Prairie Island Nuclear Generating Plant

**License Amendment Request Dated May 15, 2000
One Time Technical Specification Change
to Support Installation of MCC Transfer Switches**

LICENSE AMENDMENT REQUEST DATED MAY 15, 2000
One Time Technical Specification Change
to Support Installation of MCC Transfer Switches

Modification 99EB01

EXISTING CONFIGURATION (TYPICAL)

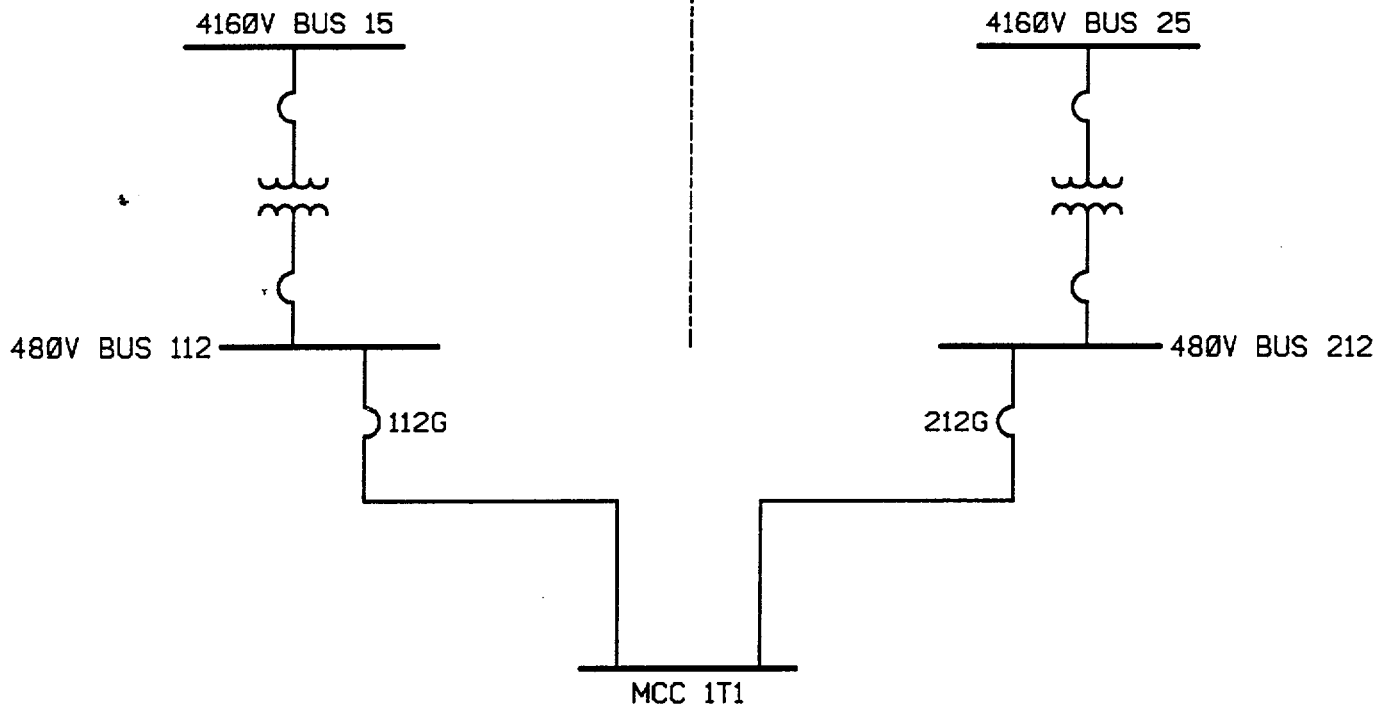
Motor Control Centers (MCC) 1T1 and 1T2 are transferable between two 480V sources, one from each unit. MCC 1T1 can be supplied from Unit 1 480V Bus 112 or from Unit 2 480V Bus 212. MCC 1T2 can be supplied from Unit 1 480V Bus 122 or from Unit 2 480V Bus 222. Refer to Figure 1 for a typical one-line diagram for the T MCCs. The T MCCs supply power to loads that are shared between Unit 1 and Unit 2.

The 480V source breakers for the two cable feeds for each MCC are electrically interlocked to prevent tying the opposite Unit 480V Buses together via the MCC. These breakers are the only isolation devices for the two cable feeds and are located at the 480 V bus source end only. There are no breakers at the MCC end of the cables; the cables are hard wired to the MCC main bus. Therefore, when the MCC is energized, both cable feeds are energized back to both 480V bus source breakers regardless of which bus is supplying the MCC. During 480V bus maintenance, all power sources to the bus are isolated, however, the energized cable from the T MCC cannot be isolated without de-energizing the T MCC. De-energizing the T MCC is not practical because of Tech Spec LCO's which apply on both units for the loads on the MCC. The energized cable and breaker stabs in the otherwise de-energized 480V bus causes a safety hazard for personnel performing 480V bus maintenance.

There have been two near-miss events, one in November of 1992 and one in April of 1999, involving energized T MCC cable in an otherwise de-energized 480V bus. This design change was initiated in response to the most recent event documented in Prairie Island Error Reduction Task Force (ERTF) Report No. 99-09. This design change will install a break-before-make transfer switch for each MCC. This switch will provide the necessary isolation to prevent the cable feed from the 480V bus that is not supplying the MCC from being energized via the MCC.

NSP	
PRAIRIE ISLAND NUCLEAR GENERATING PLANT	
PROJECT: (99EB01) 1T1/1T2 TRANSFER SW	
FIGURE 2	
CONSTRUCTION PLAN (TYPICAL)	
QA CLASS: <u>I</u>	DWG. REV. <u>0</u>
DWN. BY: <u>L. BORCHARDT</u>	DATE: <u>04/20/00</u>
CHK'D. BY: _____	DATE: _____
APP'D. BY: _____	DATE: _____
REF.	SKETCH NO. 99EB01-02

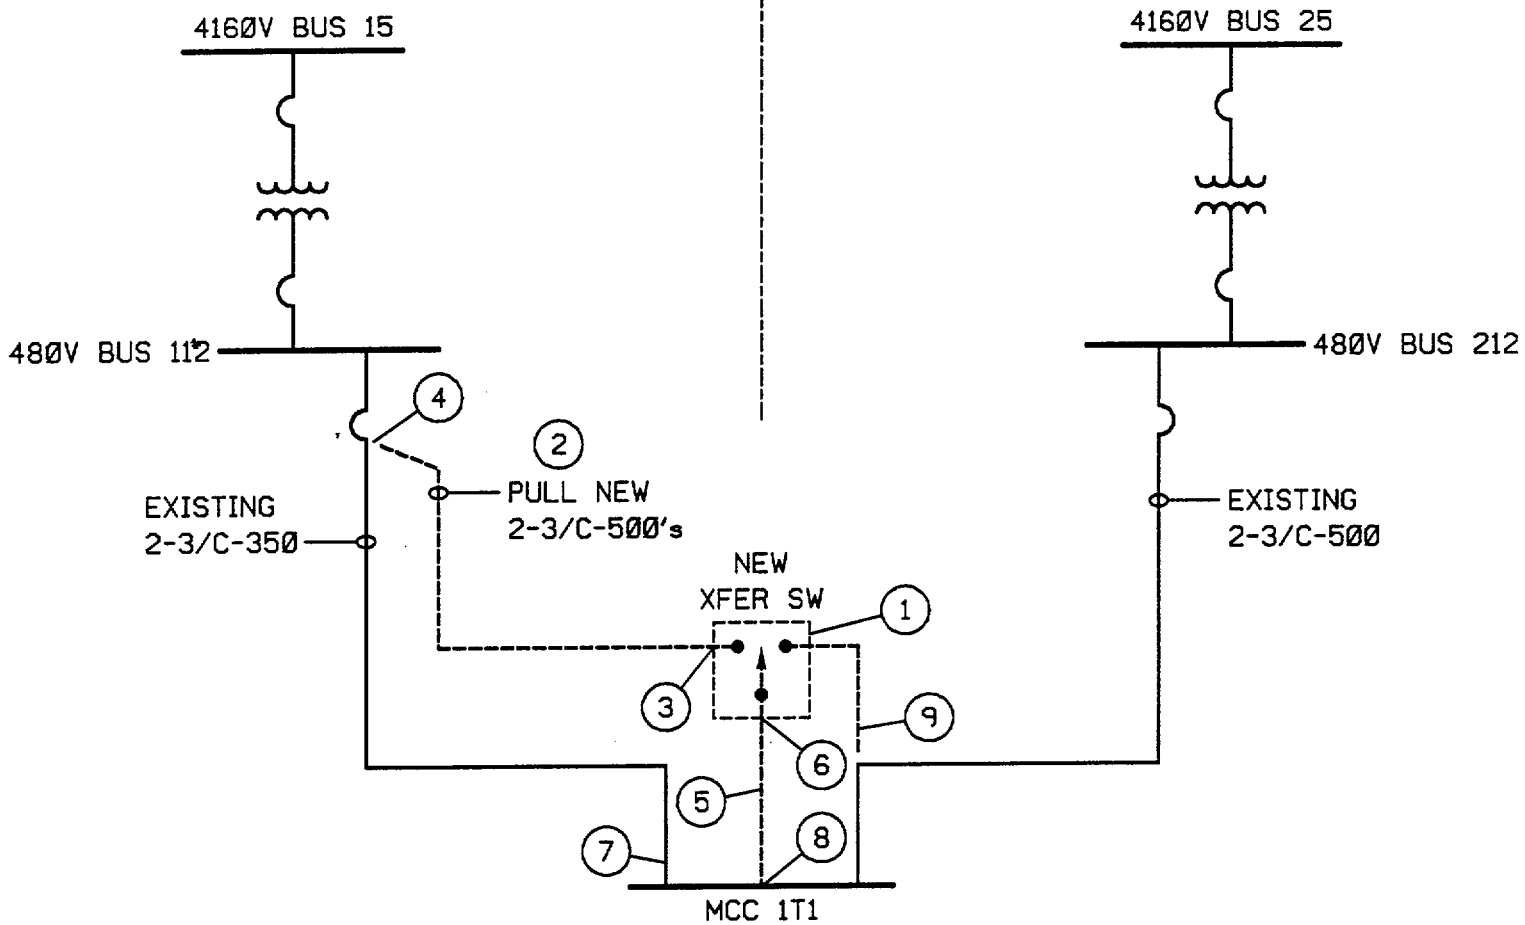
1) Preparatory Work that can be performed without an MCC outage with both units at power, and 2) the Cut-over Work that requires the MCC to isolated. The discussion here is for one MCC, the same logic applies for both MCCs. The item numbers correspond to numbers on Figure 2 for reference.

1. Install the new transfer switches in the Control Room Chiller Room near the MCC.
2. Pull new Unit 1 3/C-500 feeder cables from Unit 1 bus to the Control Room Chiller Room. This includes breaching and repair of penetrations, and any raceway installation.
3. Terminate the new Unit 1 feeder cable at the transfer switch end with no isolation.

4. Determine the Unit 1 feeder cable at the Unit 1 480V bus end and terminate the new Unit 1 feeder cable at the Unit 1 480V Bus end with the Bus energized and the load breaker isolated. Requires bus barrier installation.
5. Pull new 3/C-500 cable between new transfer switch and the MCC.
6. Terminate the new 3/C-500 between the transfer switch and the MCC at the transfer switch end only.

7. Determine the existing Unit 1 feeder cable at the MCC.
8. Terminate the new 3/C-500 between the transfer switch and the MCC at the MCC.
9. Determine the existing Unit 2 feeder cable from the MCC, pull it back into the tray, re-pull it to the Unit 2 connection on the transfer switch, and terminate it.

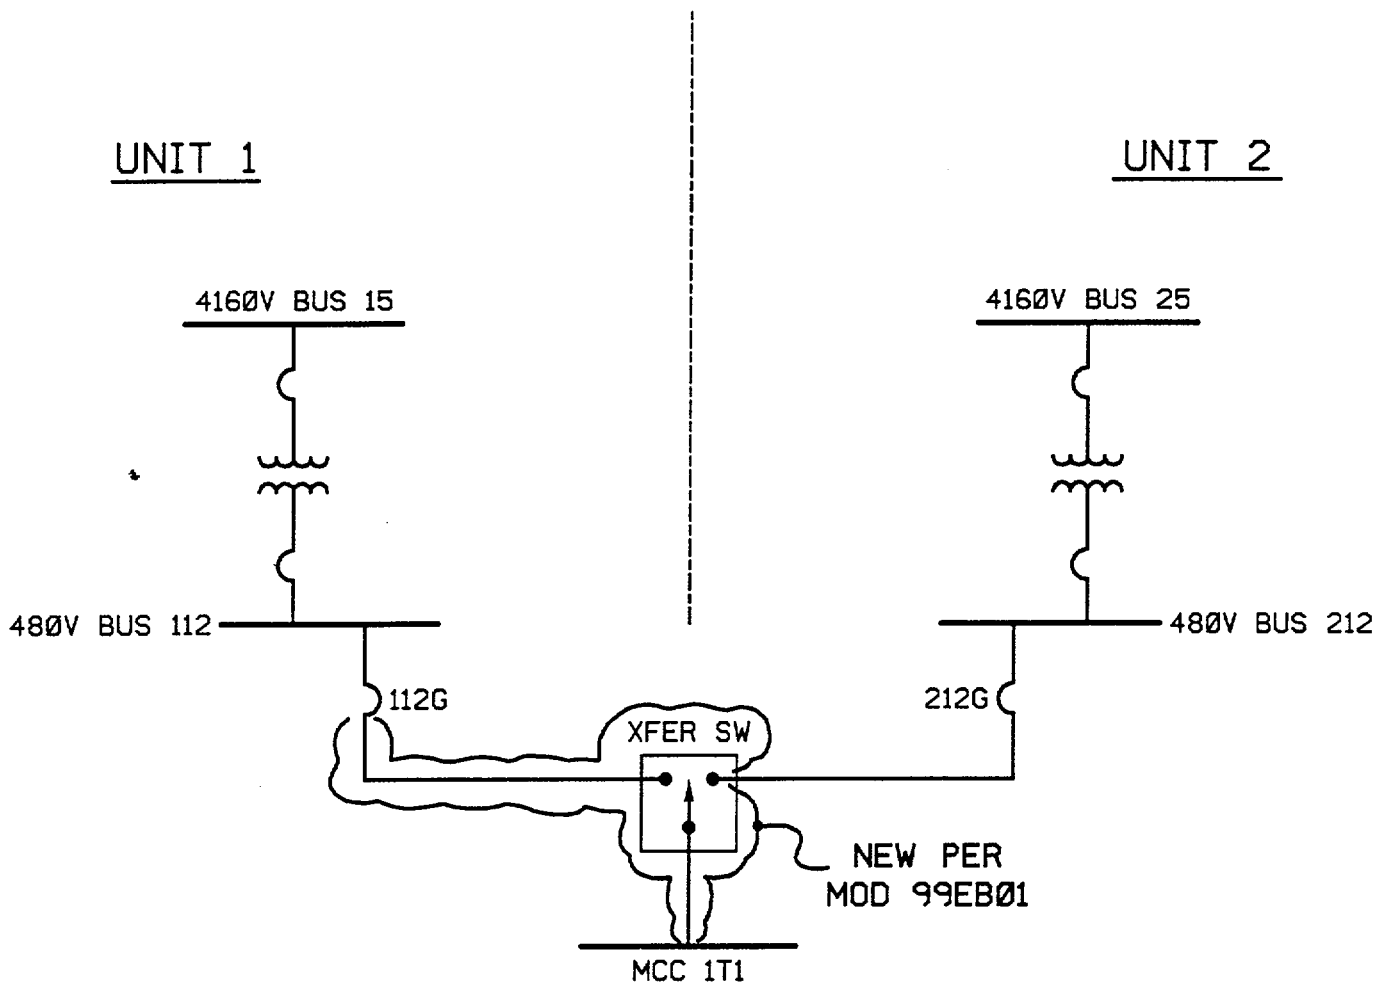
This design change will purchase, qualify, and install a break-before-make transfer switch for each of the T MCCs. Conduit and supports will also be installed for rerouted cables. Larger cables will be installed for the Unit 1 feeds to improve voltage support and ampacity of the feeds.

Two new Square D, 600 volt, 600 amp, double throw, non-fused, manual transfer switches will be purchased and qualified as Safety Related from Spectrum Technologies for this project. This is the same approach that was used for the

The transfer switch for MCC 1T1 will be installed in the 121 Control Room Chiller Room. The transfer switch for MCC 1T2 will be installed in the 122 Control Room Chiller Room. The switches will be installed just east of each MCC. Stone and Webster will provide design details for switch mounting.

The break-before-make transfer switches are not load break switches. Normal procedures (C20.6) for performing transfers with a transfer switch (AB and MA MCC's) isolate the 480V source by opening the 480V source breaker at the 480V bus. Next the transfer switch is repositioned to the desired source and then the desired 480V source breaker is closed.

The final design will retain the breaker control stations for the 480V bus source breakers in the Unit 1 480V bus rooms. The electrical interlock between breakers will also be retained. This interlock is not needed to prevent tying the opposite Unit 480V buses together anymore because the transfer switch will do that. However, the interlock does not cause any operational inconvenience so it will be left in place. The common control station helps the operator performing the transfer because the controls for both 480V source breakers for one MCC are in one location. (1T1 control station is located in the Bus 112 room and 1T2
